• • ADDENDUM # 2 ••

**PROJECT NUMBER: 130012-59
EASTERN REGIONAL WATER RECLAMATION FACILITY
OPERATIONS BUILDING RENOVATION
DUE DATE: 08/27/2025 @ 1:30 PM**

**EASTERN REGIONAL WATER RECLAMATION FACILITY
OPERATIONS BUILDING RENOVATION
PROJECT NO. 130012-59**

**CHANGES TO BID DOCUMENTS – SPECIFICATIONS AND CONTRACT
DOCUMENTS**

| CODED NOTES | |

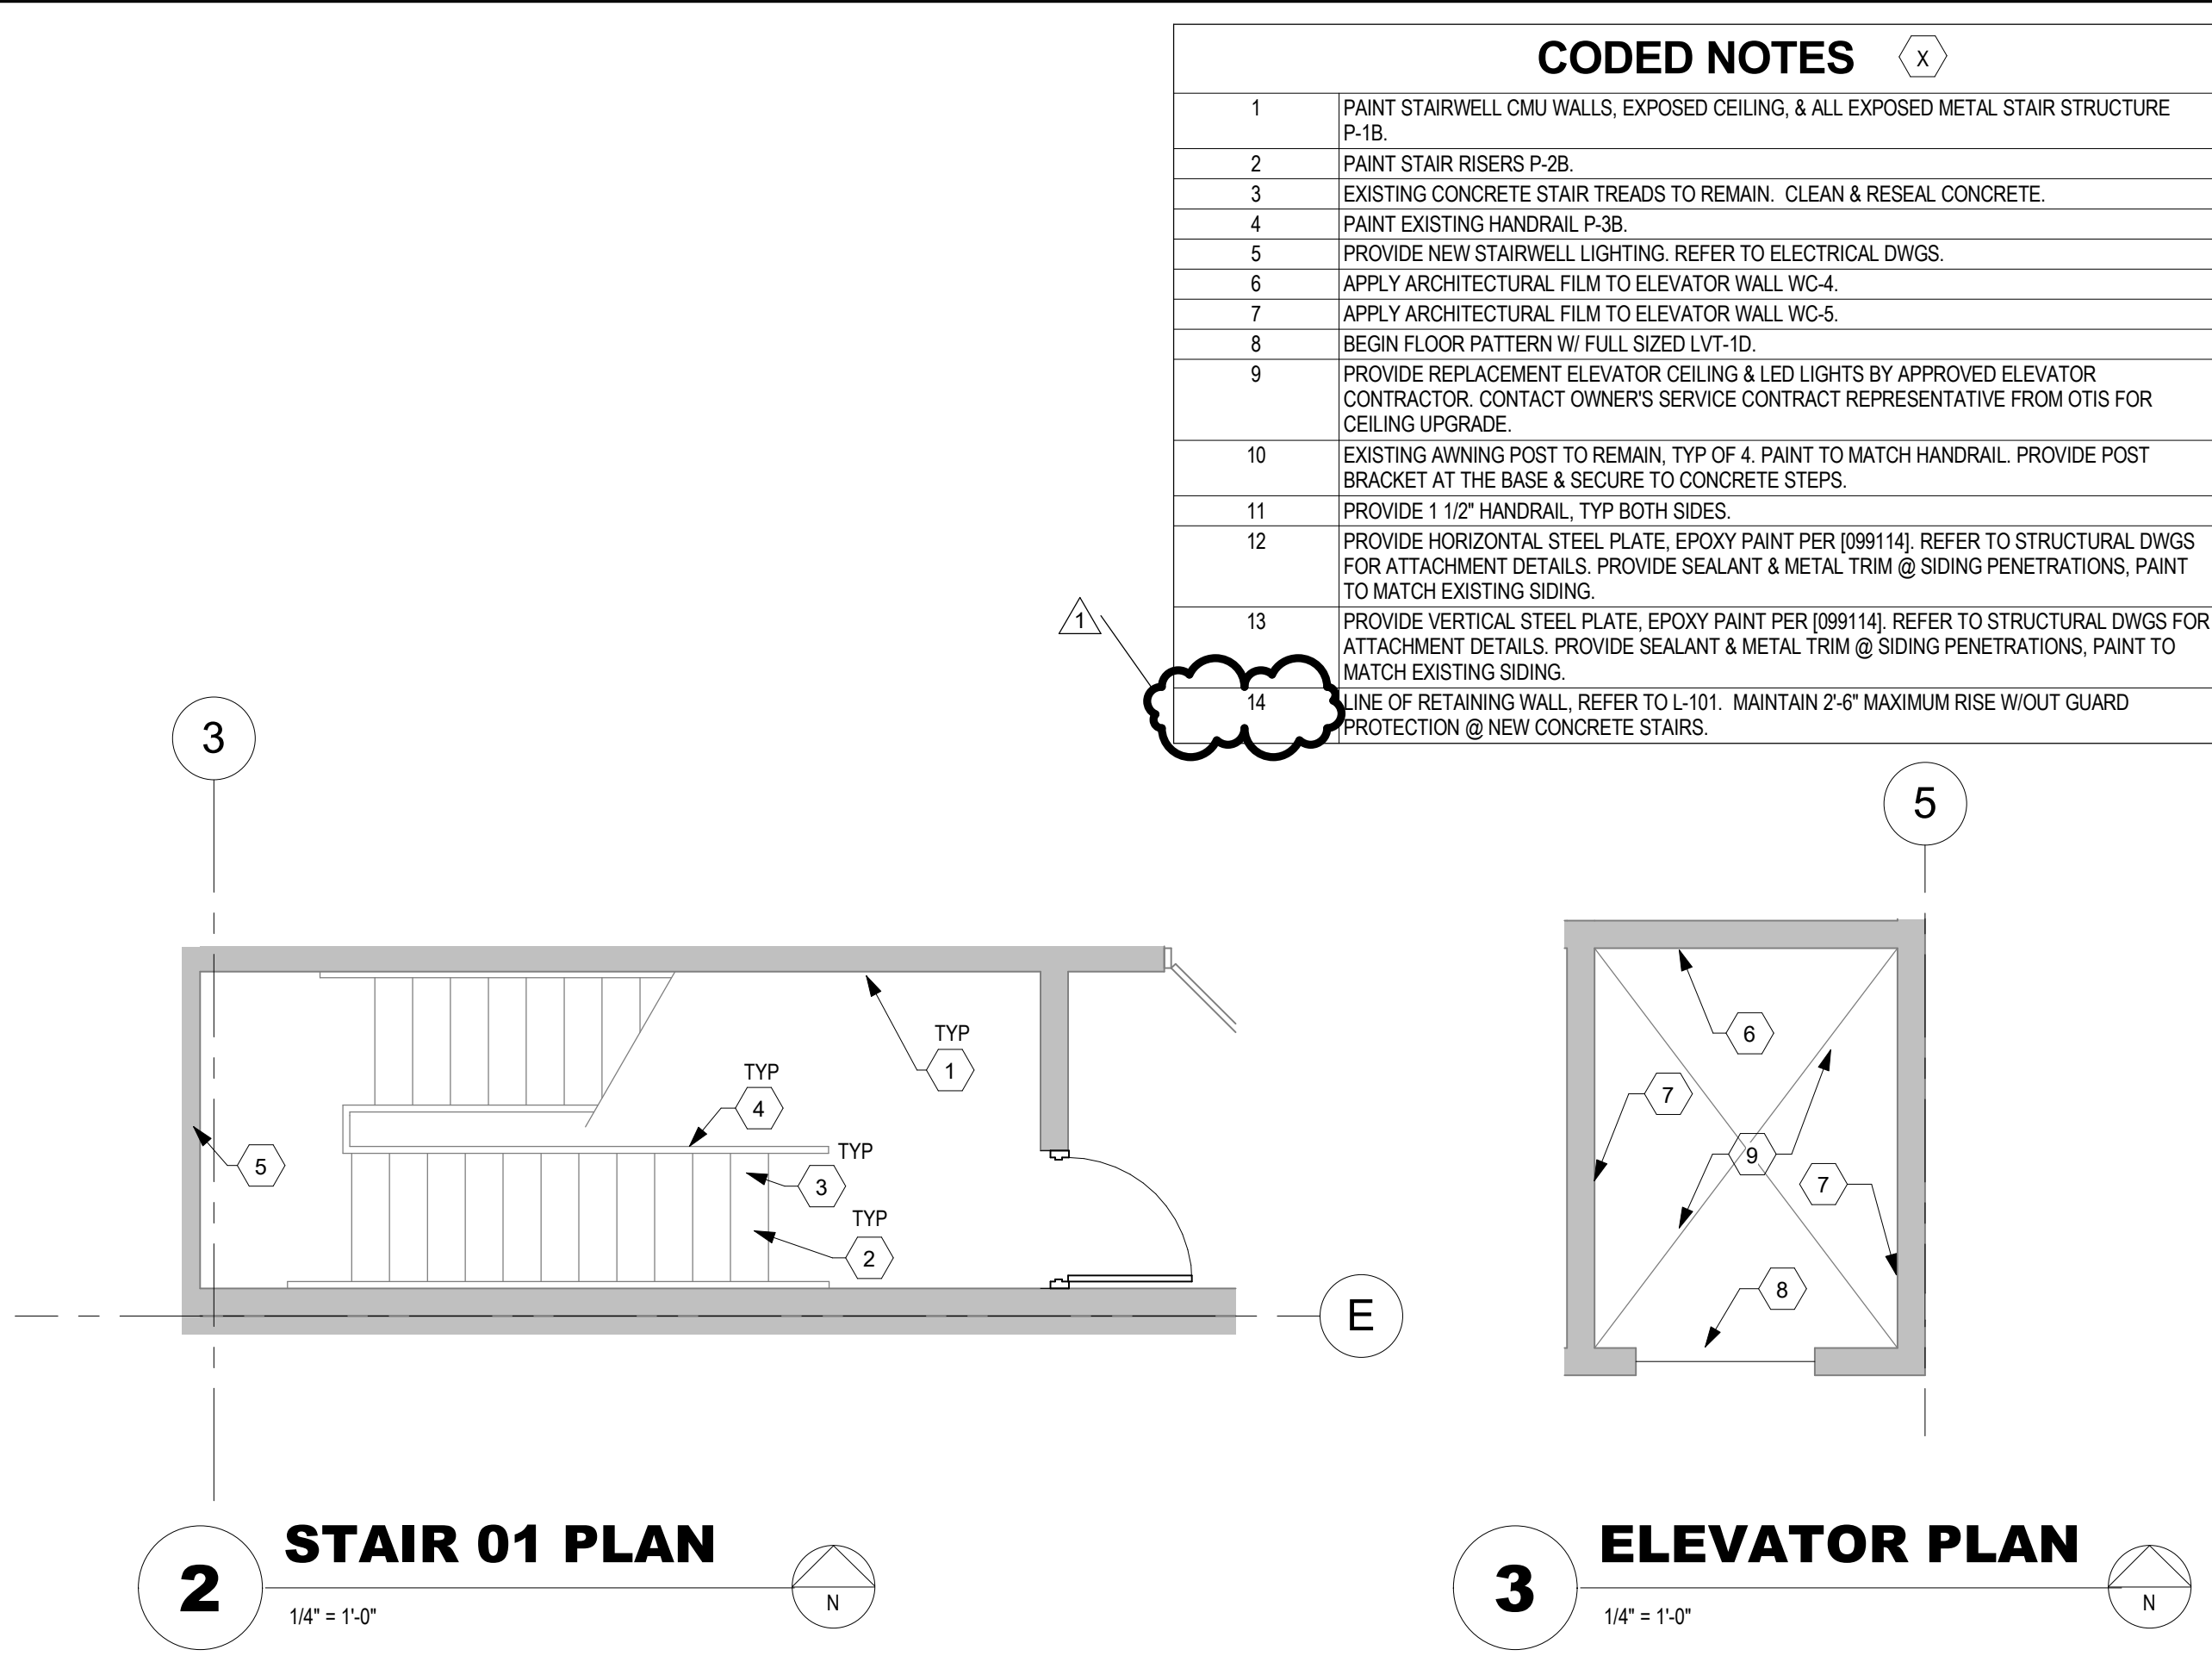
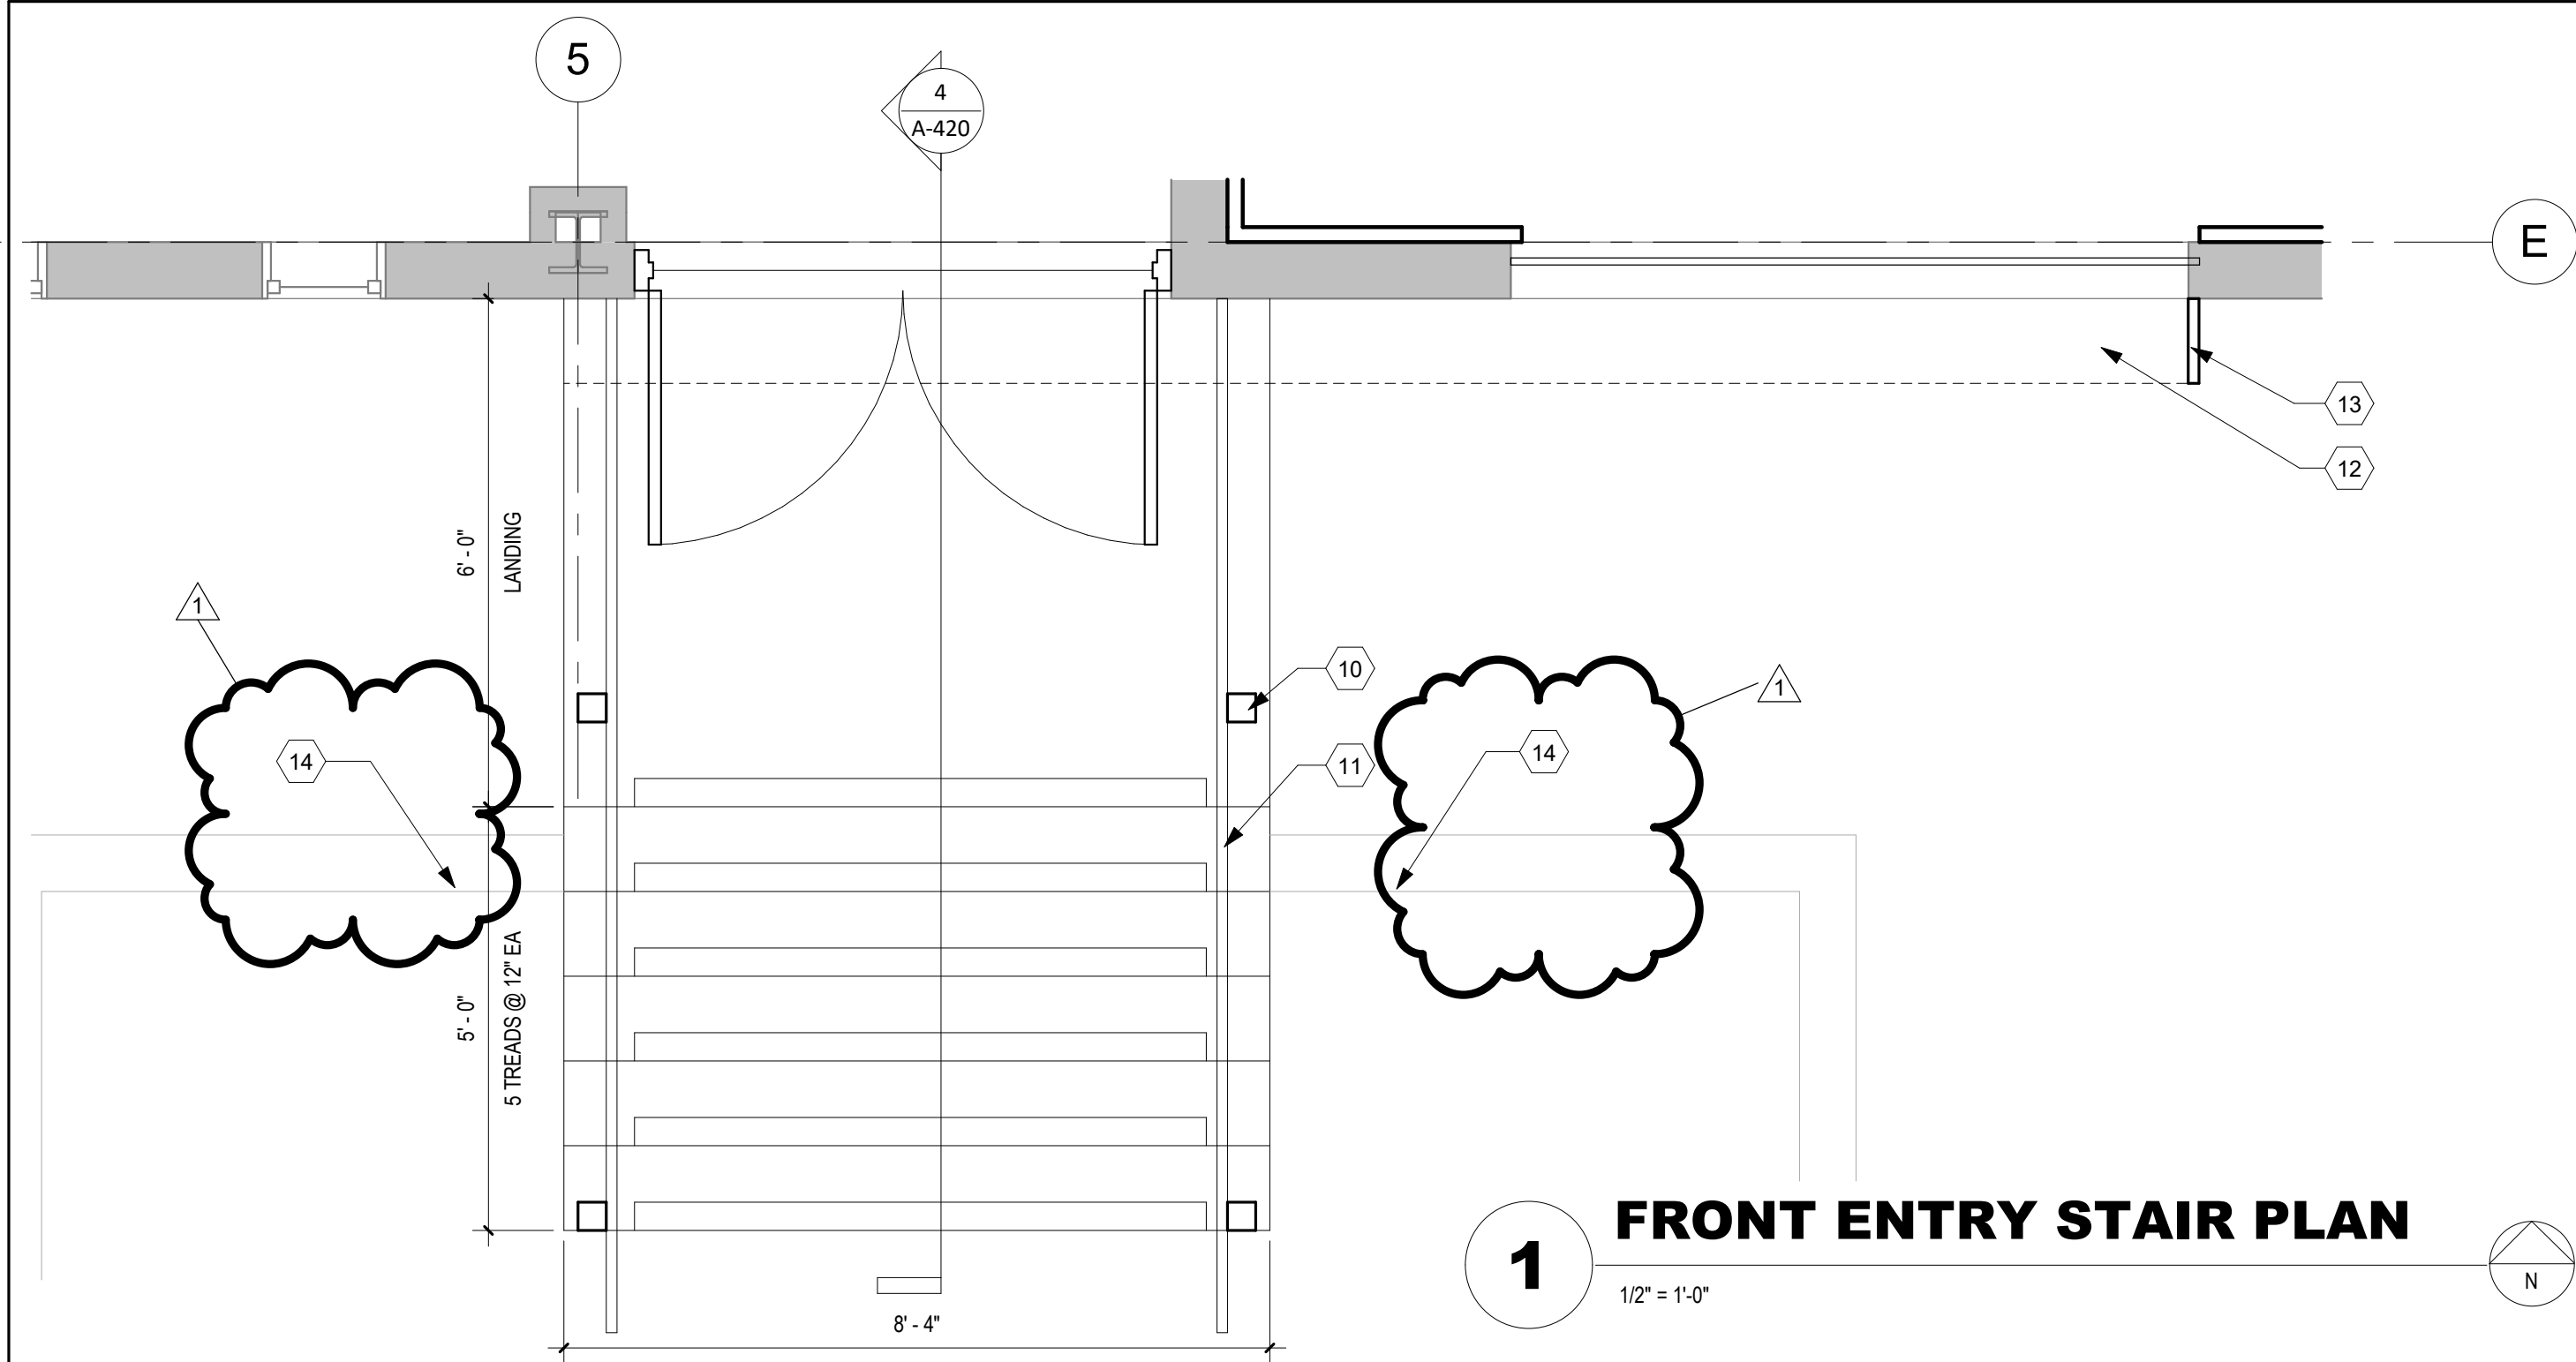
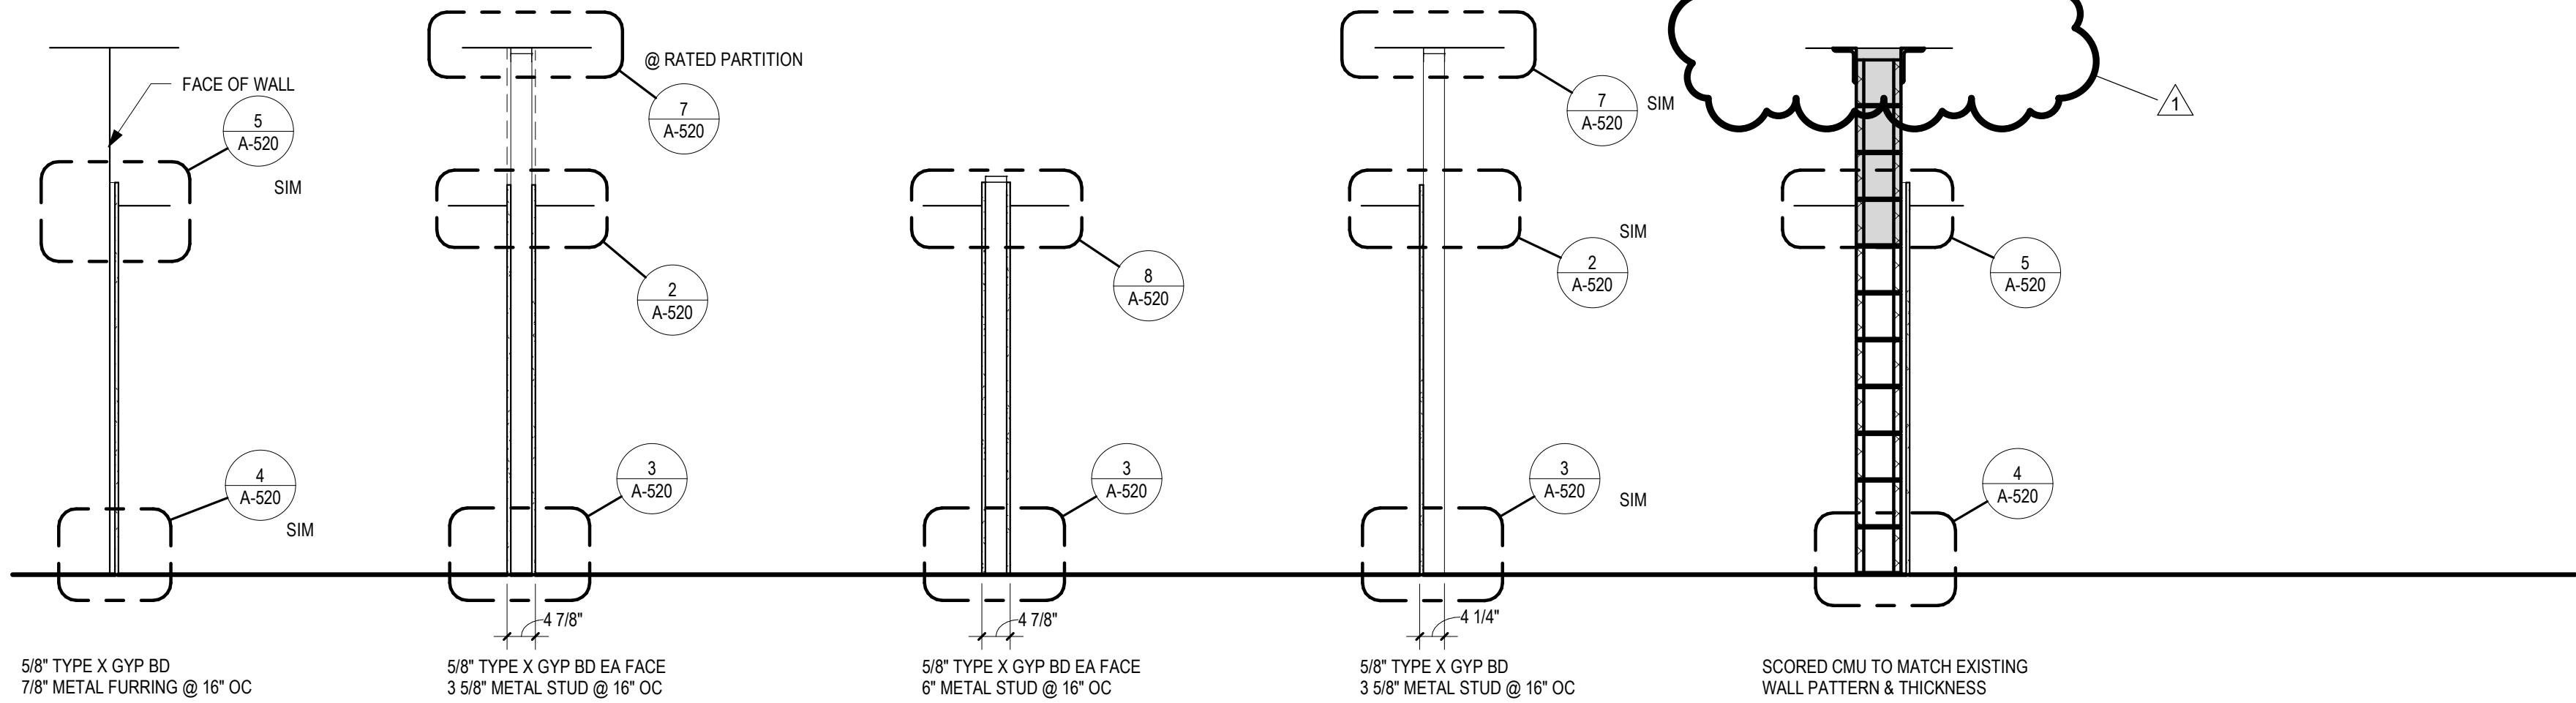
- a. Add CODED NOTE 9 per attached sheet.
9. Sheet A-420 VERTICAL CIRCULATION STAIR PLANS & SECTIONS
 - a. Add CODED NOTE 14 per attached sheet.
 - b. Add notes to section 4/A-420 per attached sheet.

| CODED NOTES | |
|-------------|--|
| 14 | LINE OF RETAINING WALL, REFER TO L-101. MAINTAIN 2'-6" MAXIMUM RISE W/OUT GUARD PROTECTION @ NEW CONCRETE STAIRS. |

1 PARTITION TYPES

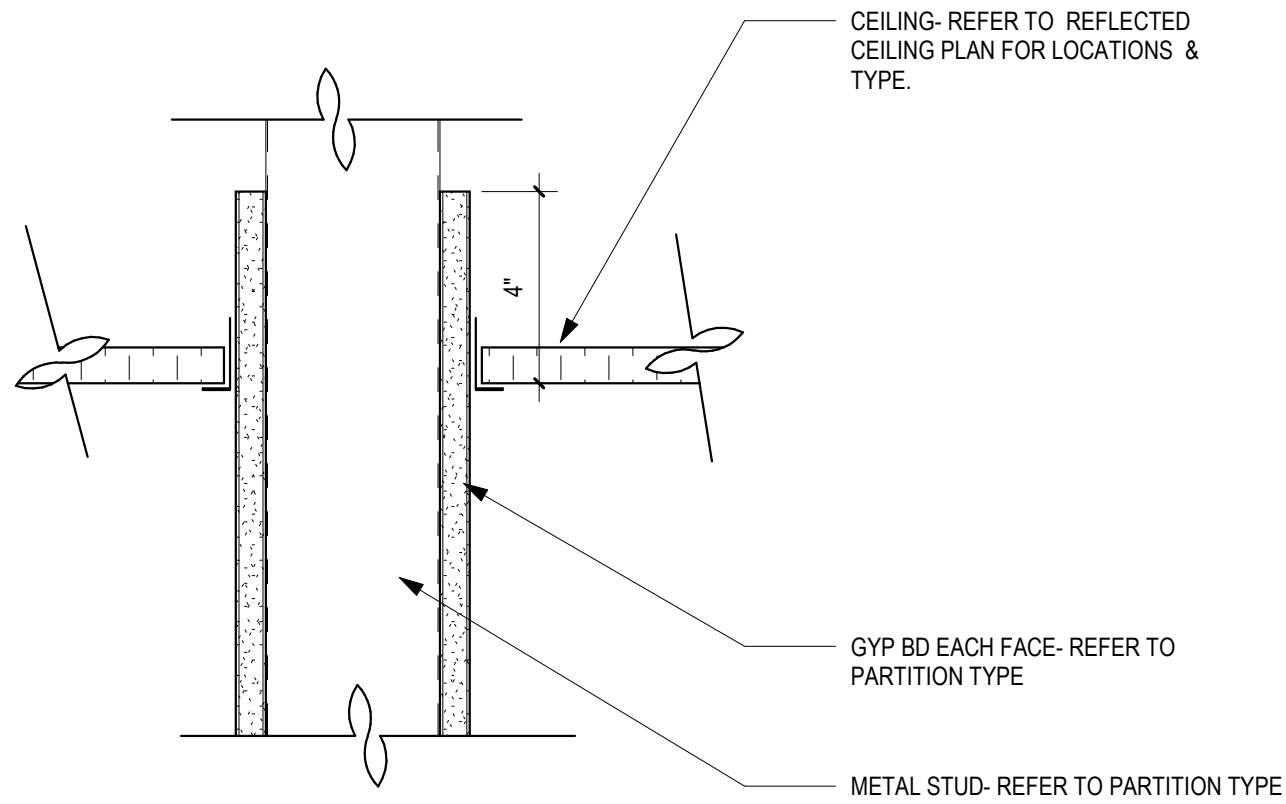
- a. Detail 1/A-520:
 - i. Revise type 1R to U465 per attached sheet.
 - ii. Add type 10R per attached sheet.
 - b. Add note to detail 7/A-520 per attached sheet.
